**Response to Request for Additional Information
Operations Permit Renewal Application
Hardee County Landfill
Hardee County, Florida**

Subject: Hardee County Landfill - Operation Permit
Pending Permit No.: 38414-007-SO, Hardee County

On behalf of Hardee County, SCS Engineers (SCS) submits the following responses to your request for additional information in a letter dated June 18, 2003. For ease of review, each FDEP comment is reiterated in bold type, followed by our response.

REVISED FIGURE 1 OF 1 VIDEOTAPE

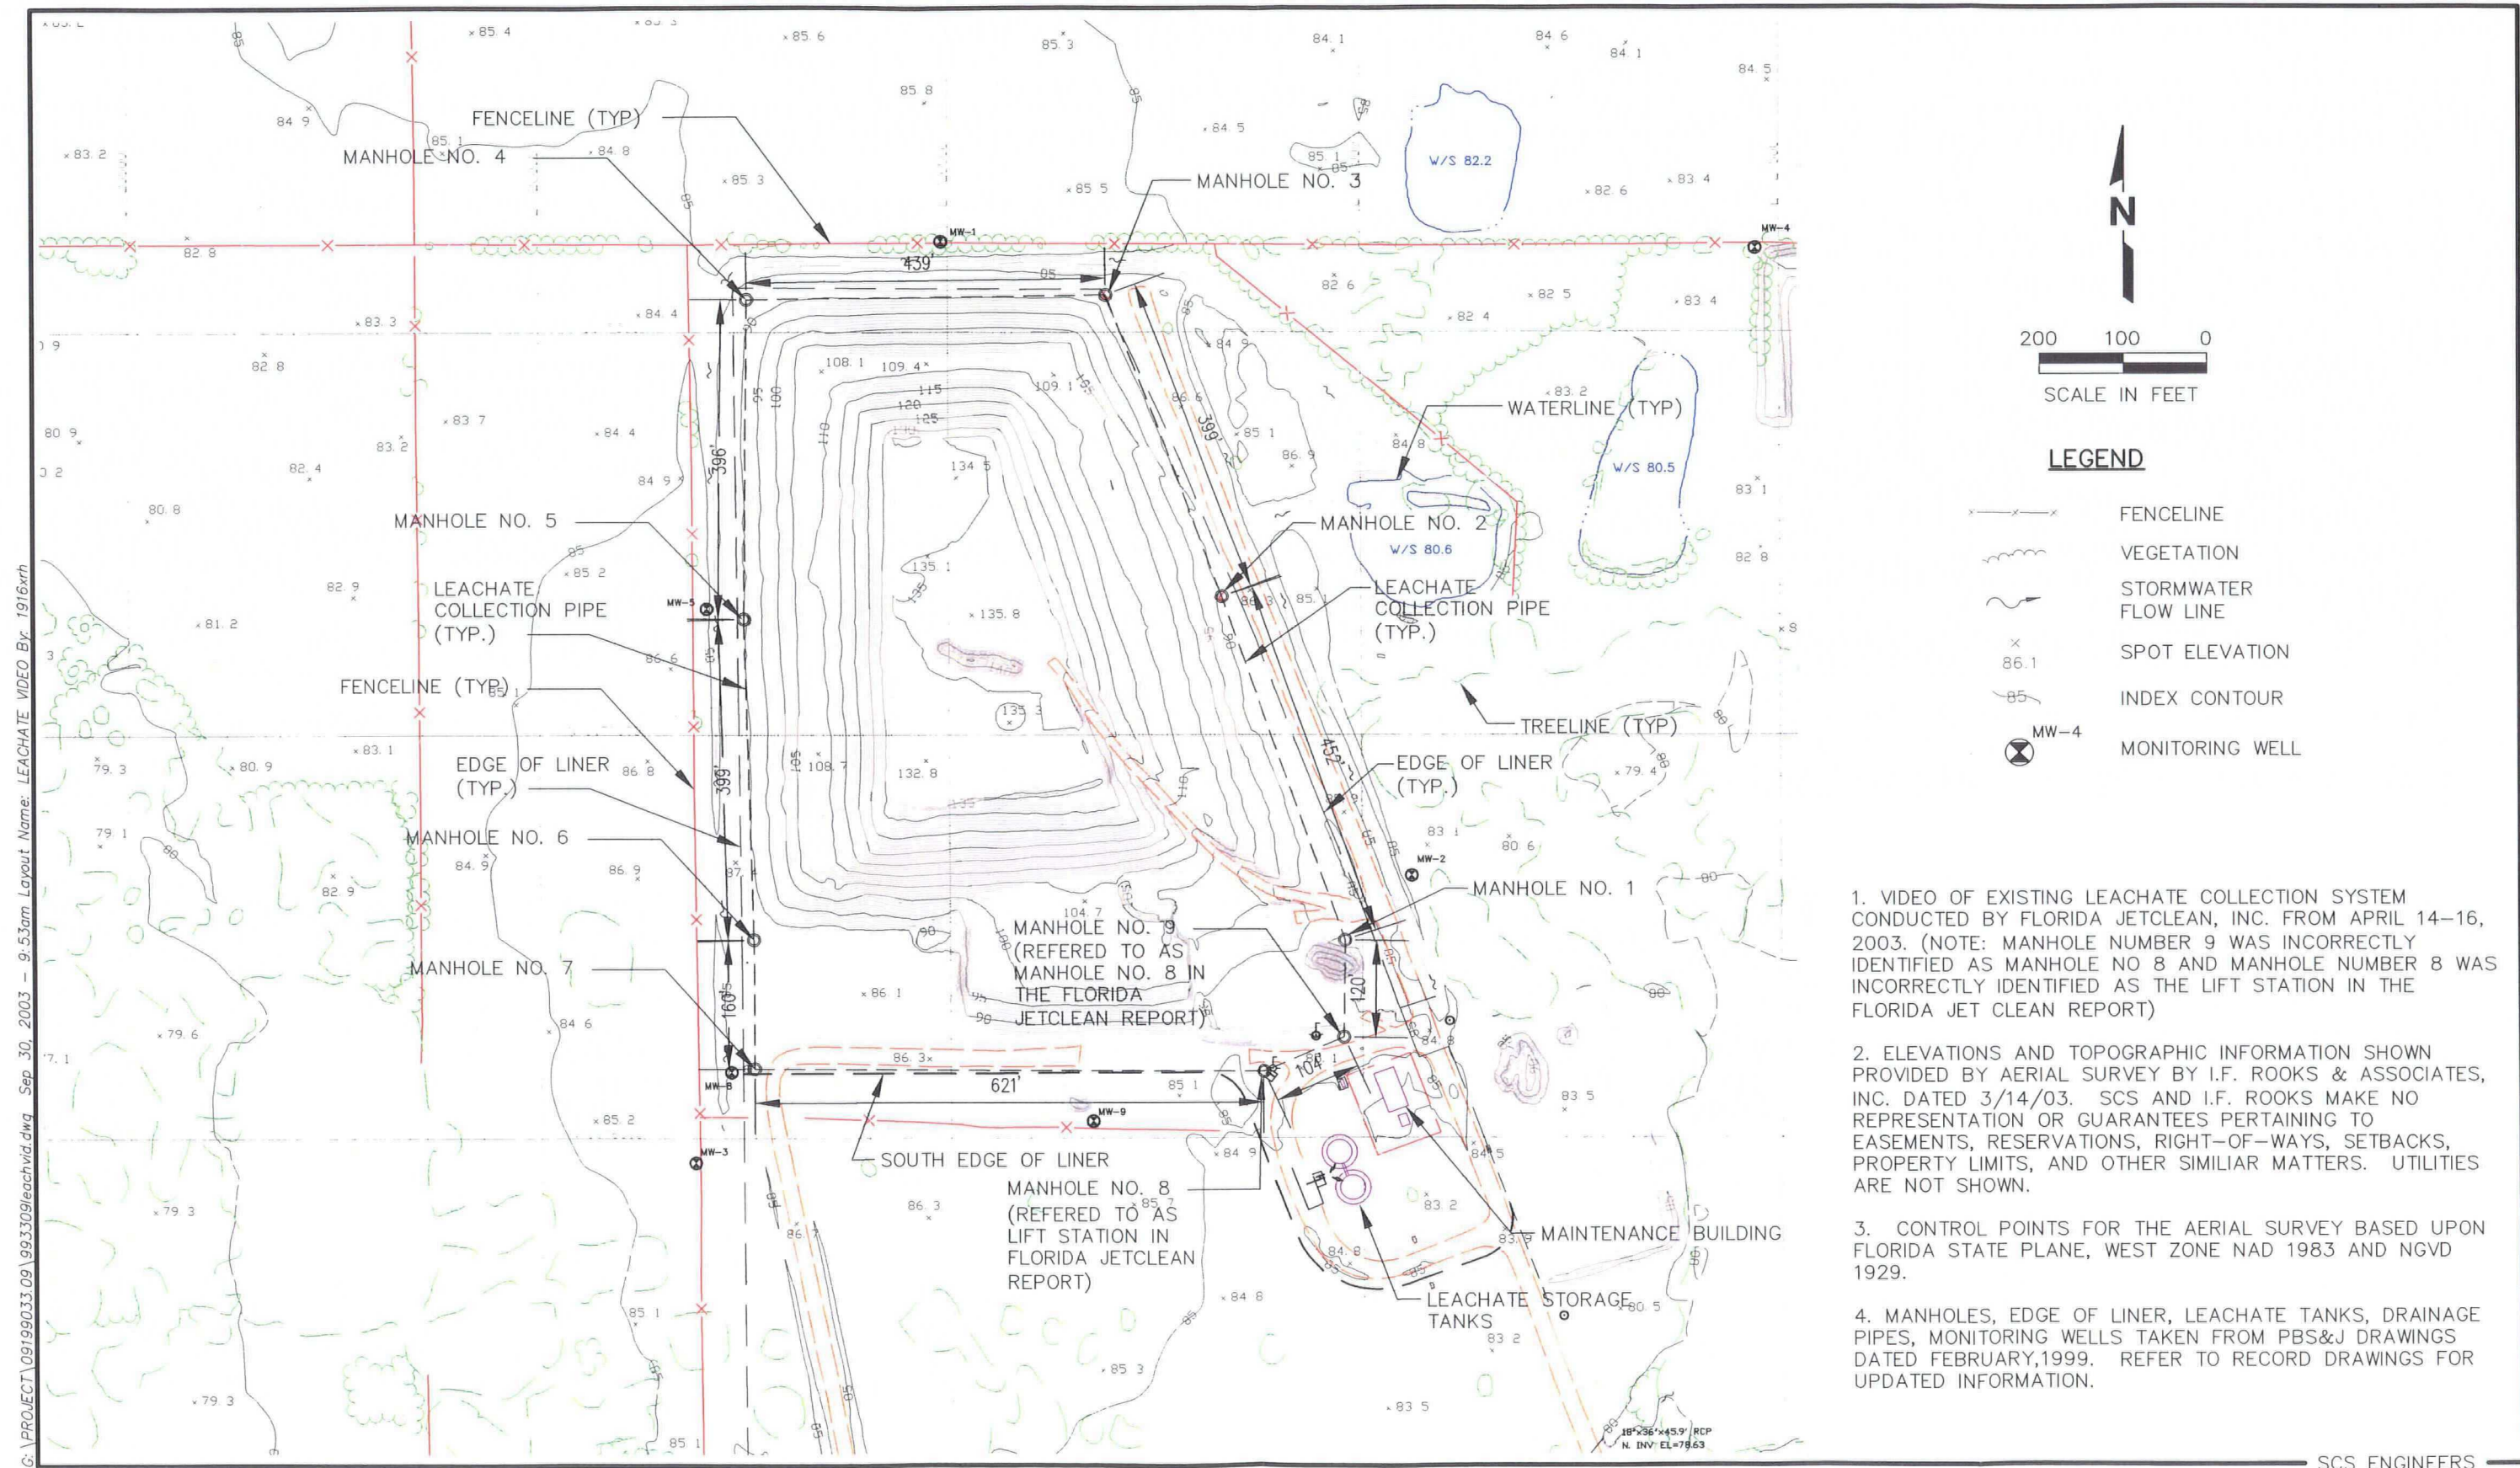
c) **A drawing to scale showing the correct numbering for each manhole.**

d) **A corrected Florida Jetclean report to include the correct numbering for each manhole.**

Response: Prior to video taping the lines, the markers for the manholes were incorrectly labeled. See the revised Figure 1 of 1, Note 1 and the description notes for Manholes 8 and 9 of the Leachate Collection Line Report, located in Attachment A-6.

Response: See the revised Figure 1 of 1, Note 1 and the description notes for Manholes 8 and 9 of the Leachate Collection Line Report, located in Attachment A-6.
